TECHNICAL INFORMATION

**LAND
-ROVER**

'E' Post Trim Area - Water Ingress

Discovery

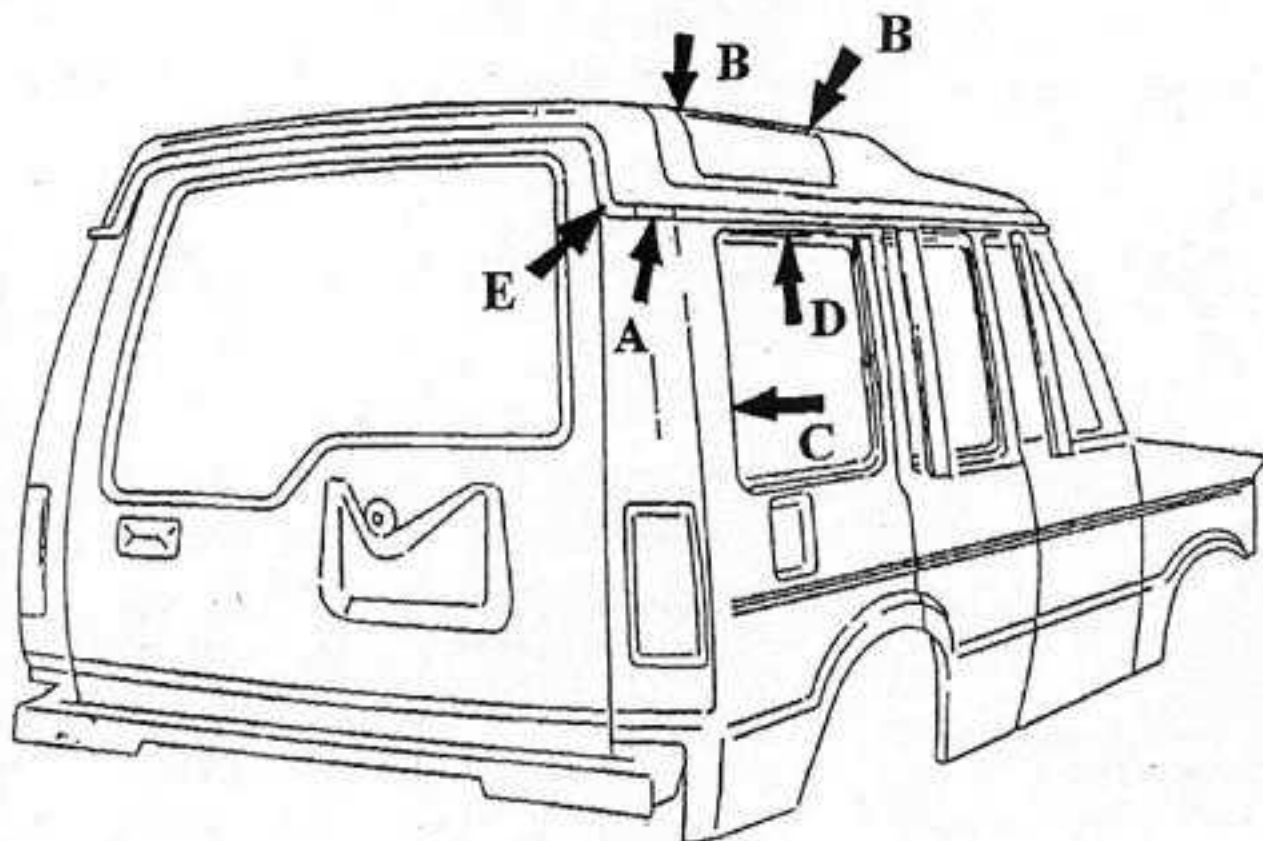
Water drips from alpine light
 (see illustration, arrow B)

Check fixed glass sealing and reseal as
 necessary (see illustration arrow C)

Check for cracks around flange see 'E' on
 illustration, reseal each side of flange.
 The flange has been moved inside can't
 rail to improve water ingress concerns from
 Vins 199607 and 530346

Inspect Zinc tape for pin holes and reseal as necessary
 (see illustration arrow A)

Inspect cantrail to bodyside joint for pin holes and reseal as necessary
 (see illustration arrow D)

Reseal alpine light glass to rubber and rubber to
 body on outside surface

1.

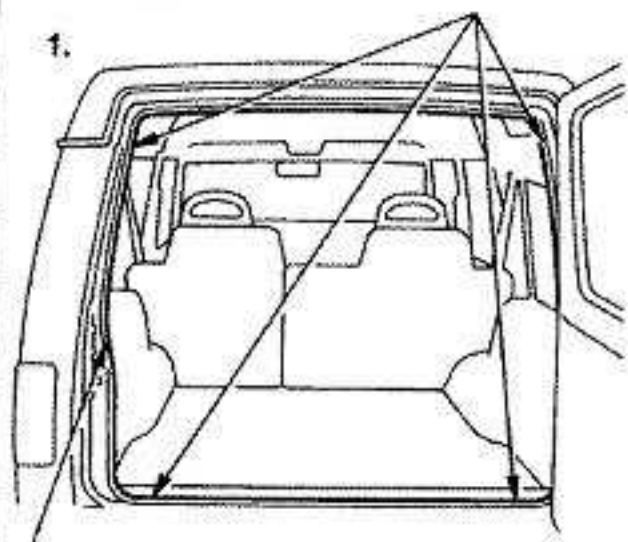
As part of ongoing quality improvements a new double bubble seal has been introduced onto the rear tail door. Early indications have identified a potential water leak from this area due to seals fitting incorrectly on a misformed seal flange. Investigations by Land Rover engineers have found that following procedure overcomes this issue on all vehicles.

1. Remove rear end door tread strip.
2. Remove rear end door seal from failed vehicle.
3. Using a craft knife, cut any excess trim tape that has been wrapped around the rear end door aperture see illustration 3.
4. Dress any flanges that appear to have panel mismatch to obtain a tight finish see illustration 1&2.
5. Smooth in Butyl around the four areas where the panel meets and form a channel to obtain a smooth finish for the foam tape see illustration 1&2.
6. Carefully apply the foam tape around the aperture as close as possible to the edge of the panel. Remove backing paper, smooth out, avoid any creases see illustration 1.

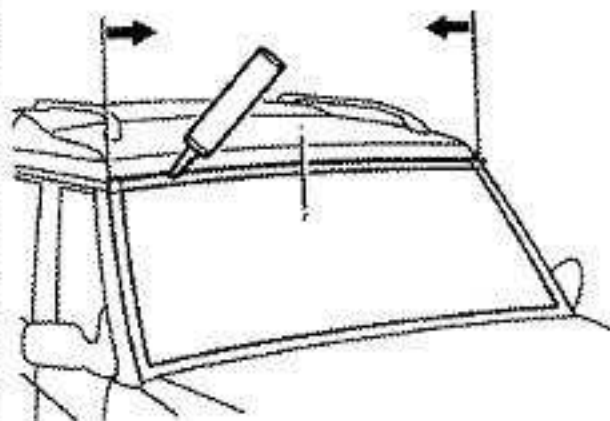
To overcome water ingress through the upper section of the windscreen seal a process has been developed to introduce a supplementary sealing operation behind the seal. Should a vehicle exhibit water ingress from this area follow the procedure below.

Locate sealant nozzle between top windscreen rubber and roof panel, extrude bead of sealant (continuous) from the centre of the vehicle towards the corners (see illustration opposite).

Care point: angle the sealant away from the painted panel.

MODIFIED GUIDE TUBE (ILLUSTRATION A)

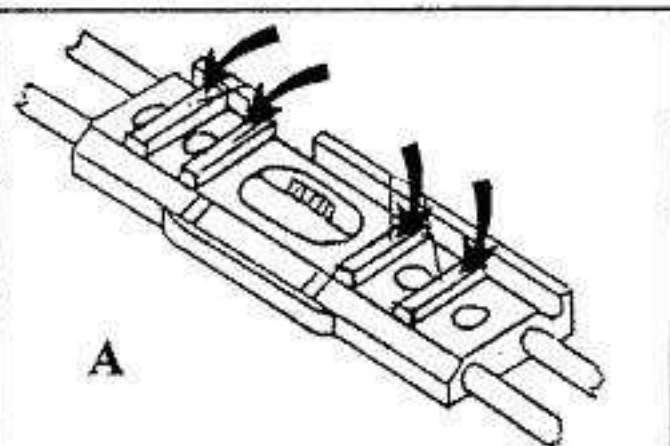
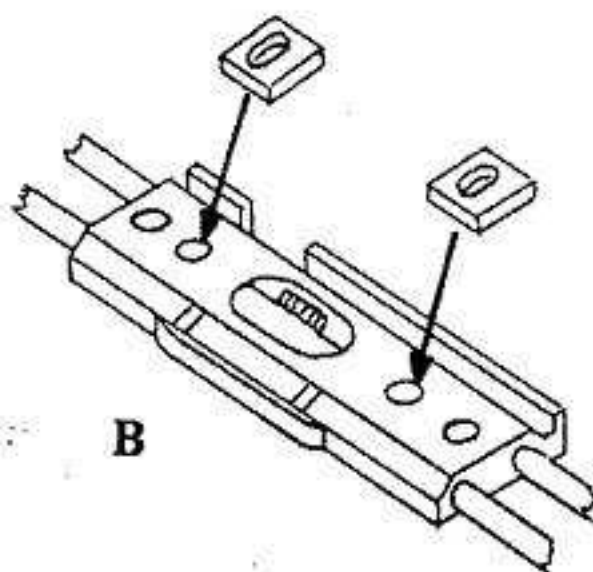
Following recent improvements to the sunroof lower tray STC 1686 and the guide tube assembly STC 1683, a spacer kit Part No STC 3194 (containing 4 white spacers) will be required if either the sunroof lower tray or the guide tube assembly are changed in vehicles prior to the Vins given.

When fitting a modified lower tray to an unmodified guide tube x 2 spacers must be fitted to the guide tube.

Gently lift the guide tube assembly off the two locating pegs on the upper frame to gain enough clearance to insert the spacers over the two inboard holes as indicated then reseal the guide tube assembly.
